PROPOSED VILLAGE OF EDEN OAK

BUILDING B SHELL
 INTERSECTION OF MARINA DRIVE, LANDMARK DRIVE & OAK HARBOR BOULEVARD
 PARCEL 14-1 OAK HARBOR
 SECTION 27 & 34, T-9-S R-14-E
 SLIDELL, LOUISIANA 70458
 ST. TAMMANY PARISH
 THIS PROJECT IS NOT FOR OCCUPANCY

This is in response to the comments received on August 14, 2025, regarding a commercial development at Parcel 14-1 in Oak Harbor Subdivision. The comments were addressed by the following:

PLAN FOR SECTION VIEWS

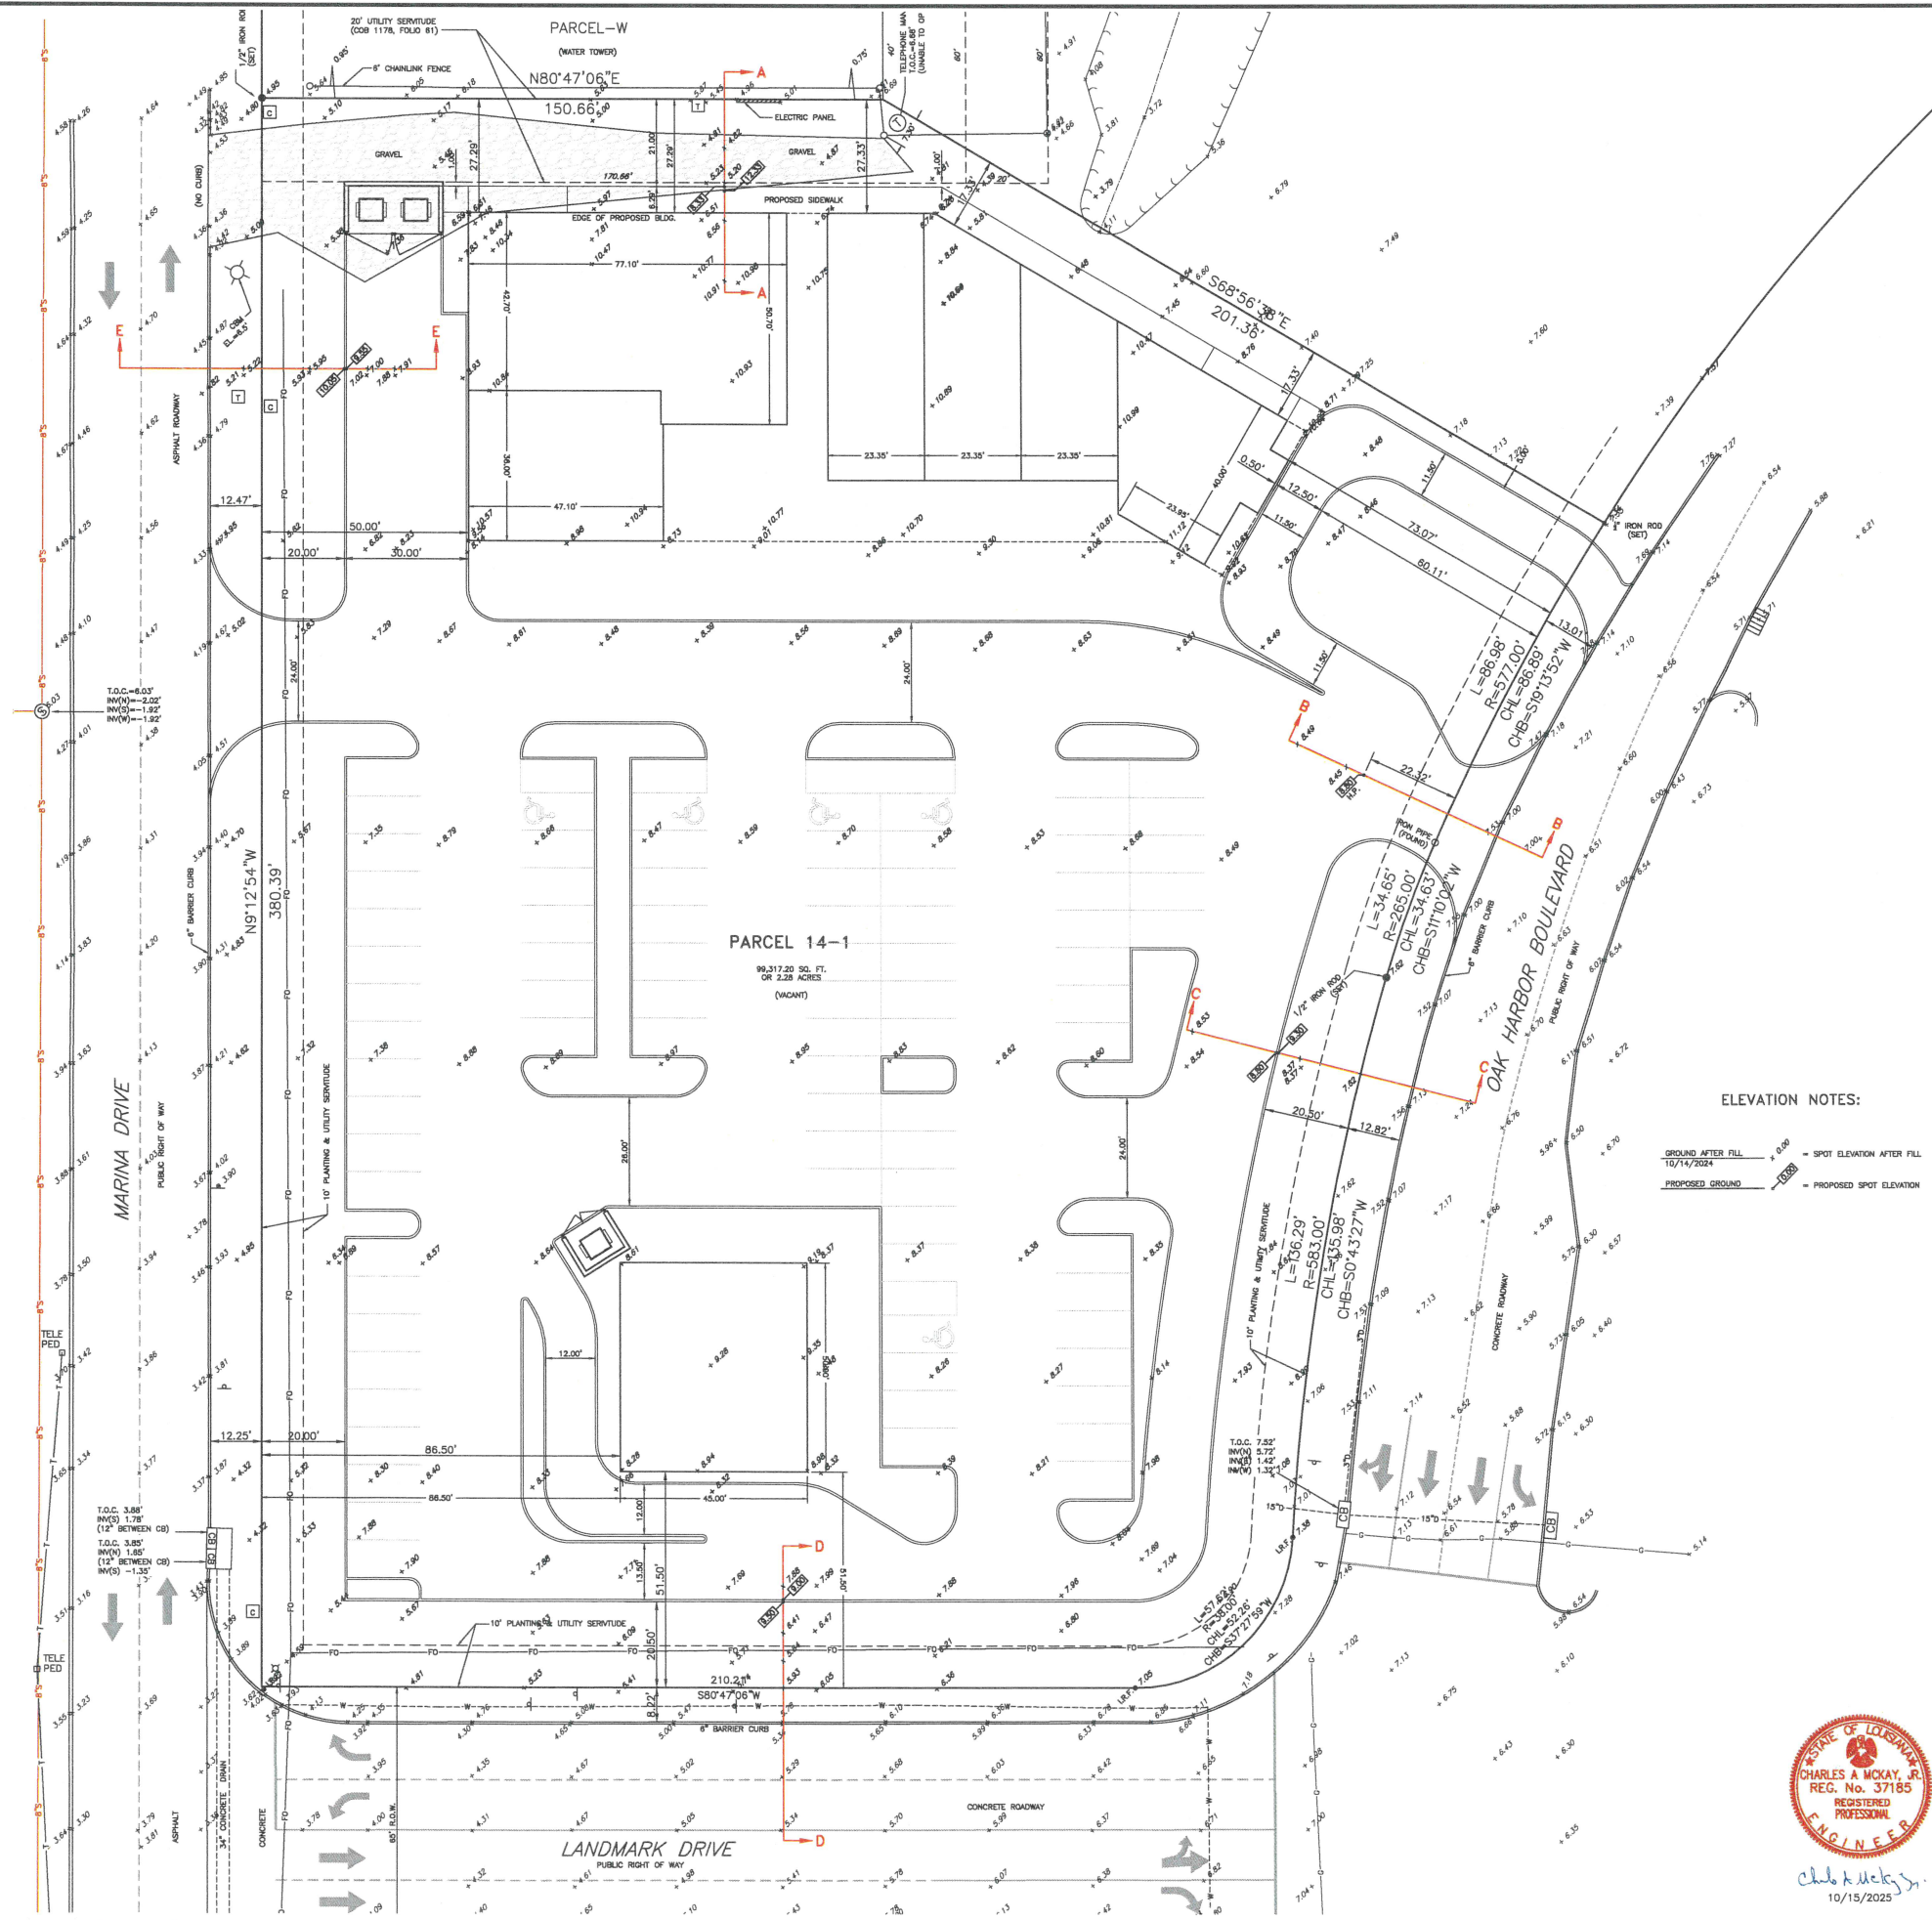
3. Cross-section - Provide cross-section including proposed elevations and dimensions from building to property line.
 - a. Refer to Exhibit No. 2 (two sheets). Sheet 1, plan view, includes location of section and the dimensions. Sheet 2 contains the section view labeled (A-A).

6. Cross-section – Provide cross-section for the driveway transition from the parish road to the finish parking lot.

7. Cross-section – Provide cross-section including proposed elevations and dimensions from edge of pavement to property line.
 - a. Refer to Exhibit No. 2 (two sheets). Sheet 1, plan view, includes location of section and the dimensions. Sheet 2 contains the section view labeled (C-C).

- a. Refer to Exhibit No. 2 (two sheets). Sheet 1, plan view, includes location of section and the dimensions. Sheet 2 contains the section view labeled (E-E).

- a. Refer to Exhibit No. 2 (two sheets). Sheet 1, plan view, includes location of section and the dimensions. Sheet 2 contains the section view labeled (B-B).

SECTION A-A

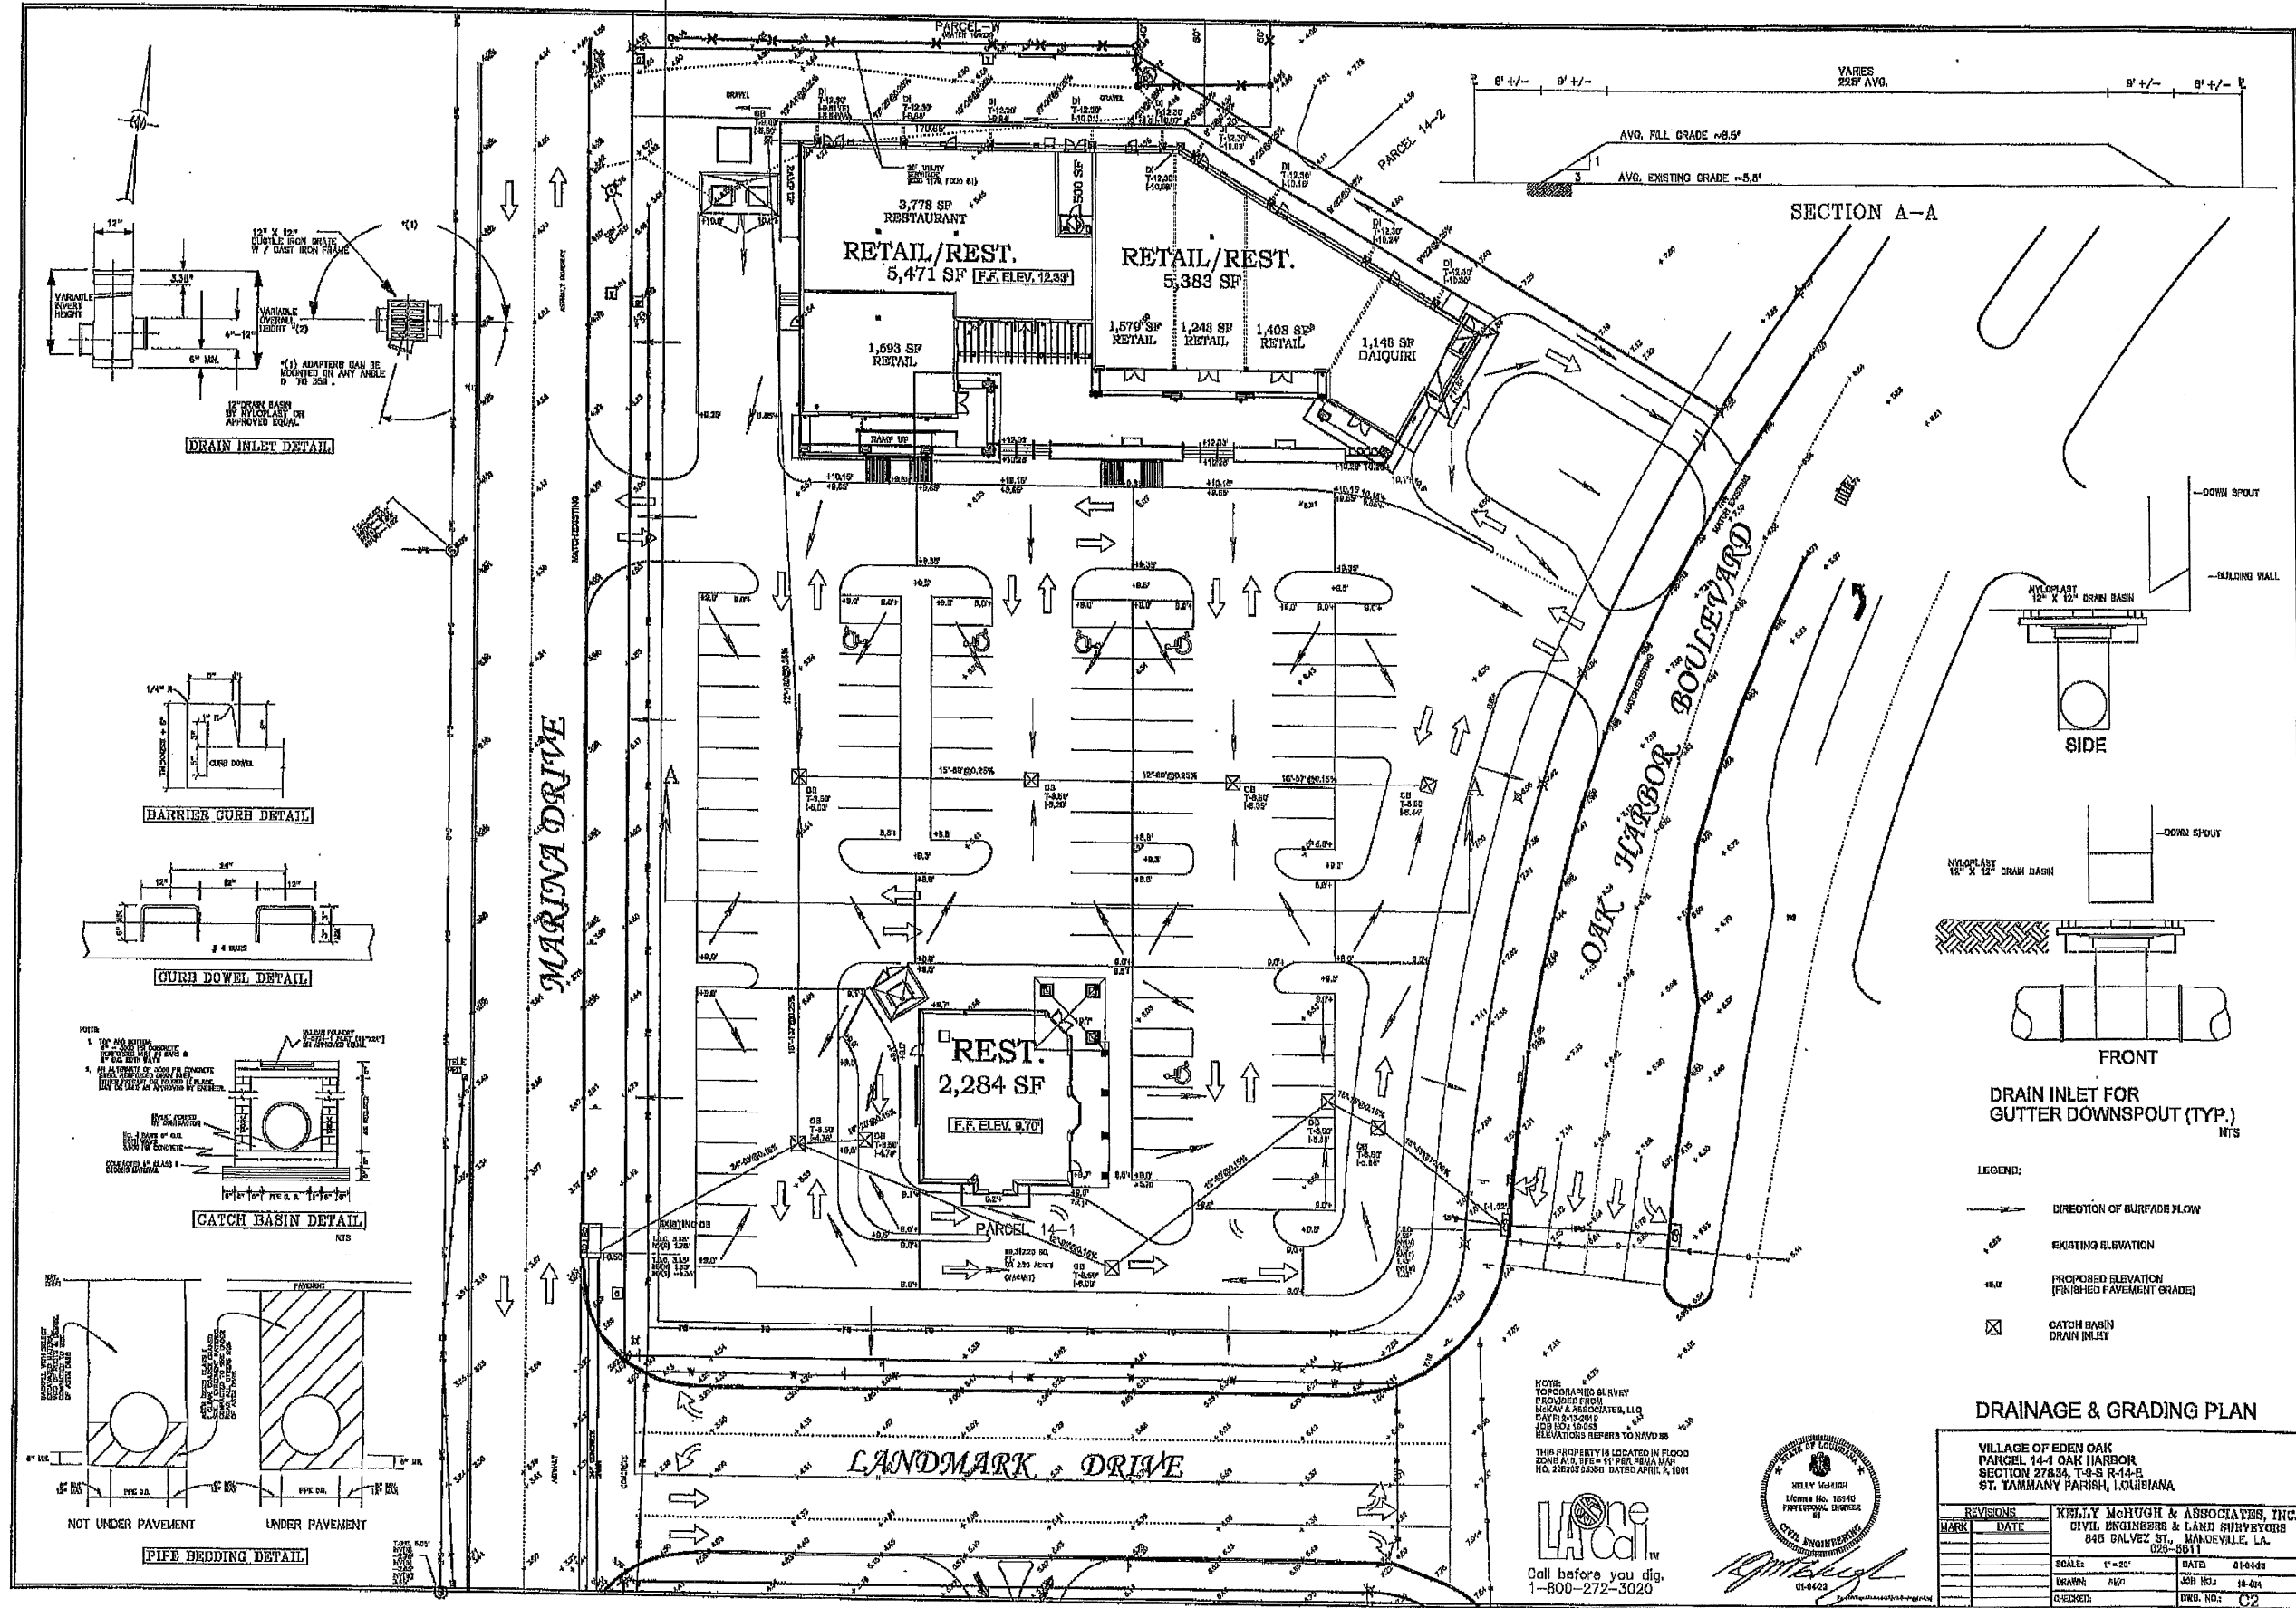
4. Cross-section – The proposed F.F.E. is ~8.5' above natural grade at this location. Show how fill will be contained. If a retaining wall is required, provide proposed construction details.

- a. Refer to Exhibit No. 2 (two sheets). Sheet 2 contains the section view labeled (A-A).
5. Cross-section – Provide cross-section including proposed elevations and dimensions from the edge of pavement to property line.
